Re: **Felder 943 Arce Tract (Amended)**

MDP # 803-A

The City Staff Development Review Committee has reviewed Felder 943 Arce Tract (amended) Master Development Plan **MDP # 803-A**. Please find enclosed a signed copy for your files. Your plan was approved for acceptance, however please note the following:

FELDER TRACT
 MASTER DEVELOPMENT PLAN
 AMENDMENT NO. 803-A

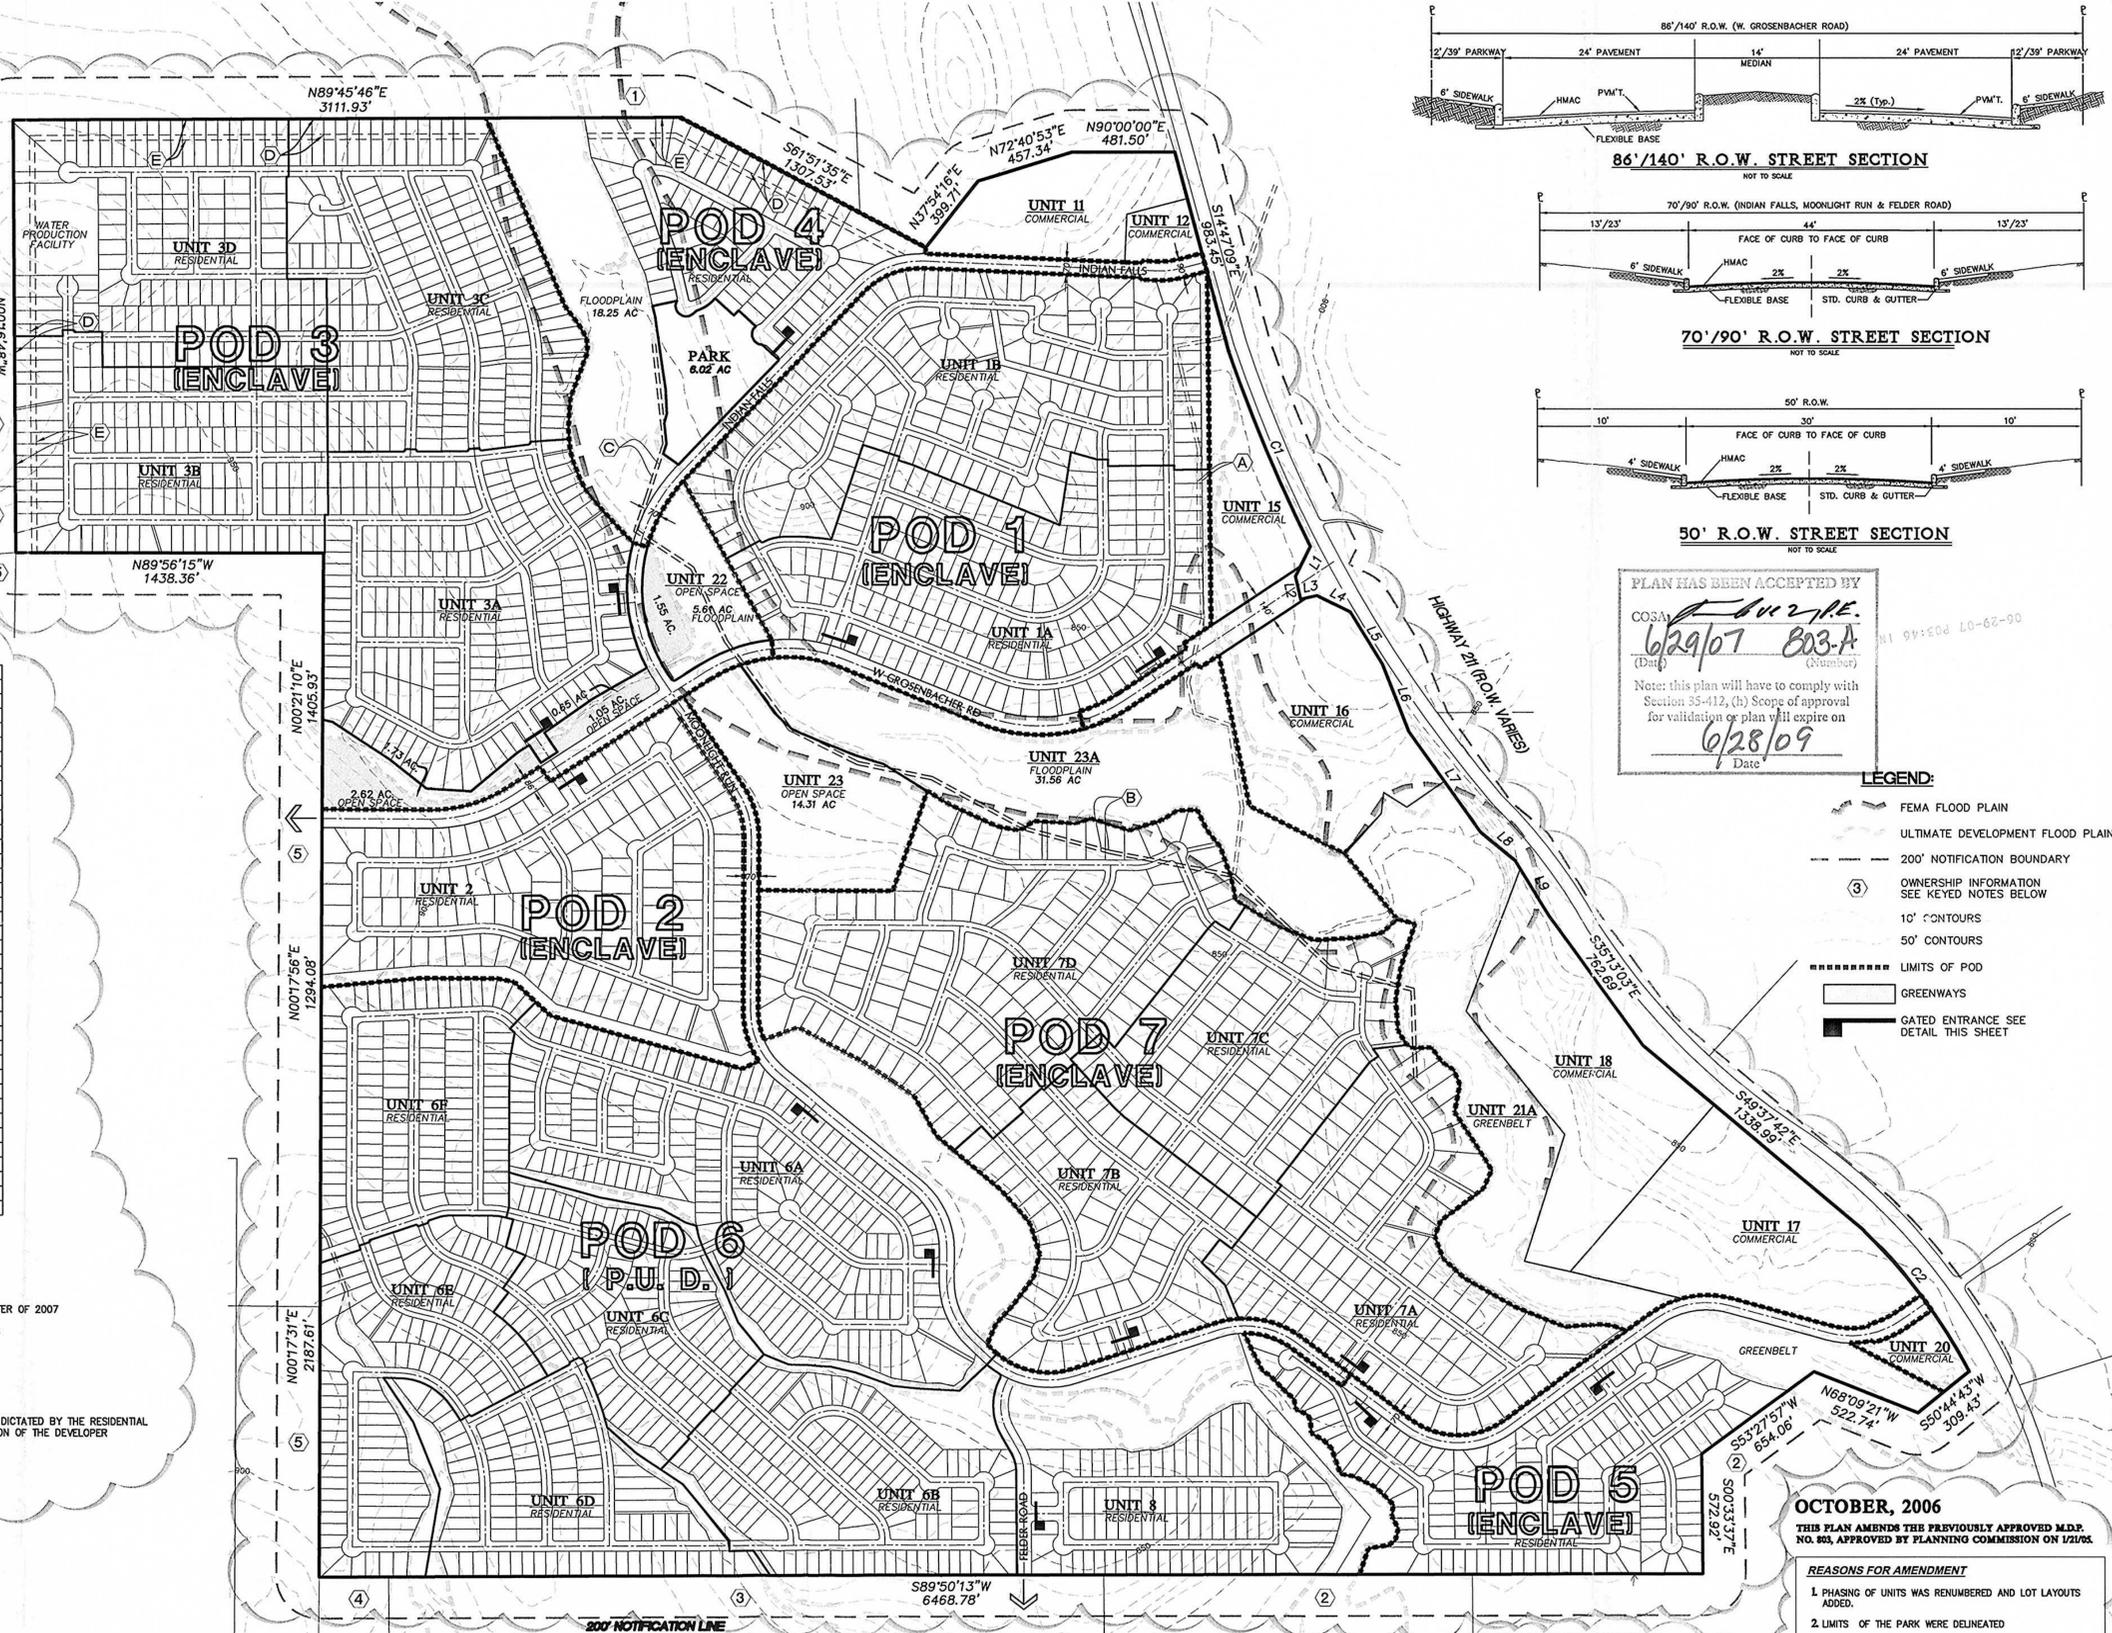
In consideration of public safety and convenience, excessive grades by reason of topography should be avoided in street layouts and arrangements. Any access and R.O.W. issues along state facilities will need to be resolved with the **Texas Department of Transportation (TxDOT)**. For information about these requirements you can contact TxDOT at 615-5814.

The following improvements, are necessary and shall be provided by the developer at the time of platting for the proposed Felder Tract development, at no cost to the City of San Antonio:

- Development of the individual units should incorporate an overall access strategy that will allow major, signalized access along Marbach and SH 211. The signalized location should be planned to occur at ½ – mile (preferred, intervals) or approximately ¼ – mile (absolute minimum intervals). Good consistent spacing in multiples of ¼ - mile will provide for future two-way progressive coordination. Uneven spacing of traffic signals will decrease the ability to provide good two-way progression, thereby degrading future traffic flow along the arterials. Each signalized intersection should have a minimum of two approach lanes on any minor street. Intersections should be flared as necessary to provide dedicated left and right-turn lanes. The developer is responsible for the design and placement of all traffic signals when warranted. The City of San Antonio Public Works Traffic Department shall approve all traffic signals.

- Marbach Road - Dedicate 86-feet of ROW and construct a 4-lane divided roadway (Secondary Arterial Type A). The limits of construction shall be extended through the Felder Tract development as shown on the City of San Antonio Major Thoroughfare Plan.

- Marbach Road and State Highway 211 – It is recommended that within 600 feet of the intersection with State Highway 211 and on both sides of Marbach Road, that this right-of-way dedication be expanded to 140 feet to allow for future turning lanes. ROW dedication is shown on the Felder Tract MDP.

- Construction of an internal loop collector street system approximately 2 miles in length. The internal collector will extend from SH 211 north to Marbach Road and from Marbach Road to SH 211 south. Collector street design parameters consist of minimum 70-feet of ROW and minimum 44-feet of pavement (Table 506-3). The proposed collector street shall have no houses fronting (UDC 35-515, (c), (4)).

- Provide left-turn lanes and right turn deceleration lanes along the proposed collector and along Marbach Extension at project driveways and internal residential roadways. Development Services TIA Division, Public Works and Development Services Streets Division will determine storage capacity and taper length at the time of platting based on traffic data provided in the Level 3 TIA.

- Construct right-turn deceleration lanes at each project roadway and driveway along SH 211. Deceleration lanes shall be 510 feet in length, inclusive of a 210 feet straight line taper to accommodate posted speeds of 65 mph.

- Construct project driveways with throat lengths in accordance with the City of San Antonio Unified Development Code 35-506 (r).
- Provide clear sight distance at each roadway to provide adequate obstruction free viewing distances for approaching traffic. All signage, landscaping, and improvements shall be selected and located so as to not block these clear sight distance areas.

- Traffic signalization is required at the follow on-site intersections:
 1. State Highway 211 and Proposed Collector (North)
 2. State Highway 211 and Marbach Road

3. State Highway 211 and Proposed Collector (South)

It should be understood that the submitted TLA concurrent with the proposed Felder Tract MDP is a conceptual plan and therefore this document does not represent an approval for the internal street plan. All streets shall follow UDC 35-506 and the street network shall be planned in order to provide safe and efficient movement of traffic to and from, within and past, the proposed development, while minimizing the impact to non-site trips. UDC 35-506 will be implemented at the time of platting.

- 2003 Tree Preservation ordinance standards per UDC Section 35-523 for both residential and commercial development – a Tree Permit is required prior to any work on site. This can be submitted either as a clearing permit or at the platting stage. This project appears to be suited to a Tree Stand Delineation; note that flood plain area must be delineated separately (preserved at 80% for significant trees and 100% for heritage trees). A ROW clearing permit, AP 1314857 has been issued for entire MDP area – note that work on lots and easement clearing is not allowed under current permit.
- Streetscape standards per UDC Section 35-512 - New ROWs (W Grosenbacher, Golden Rain, Indian Falls) will require streetscaping (we recommend preservation of existing trees where available and possible).

- The parkland provided shall be shown as “Park” or “Open Space” on a plat; UDC section 35-503(e) *Designation of Parkland*.
- The parkland provided is dedicated to the Home Owners Association.

- The instruments creating the Home Owners Association are provided by the second application for plat approval; UDC section 35-503(e) *Designation of Parkland*.

Parkland dedication must be platted by the second phase of residential development; UDC section 35-503(f) *Development Phasing*
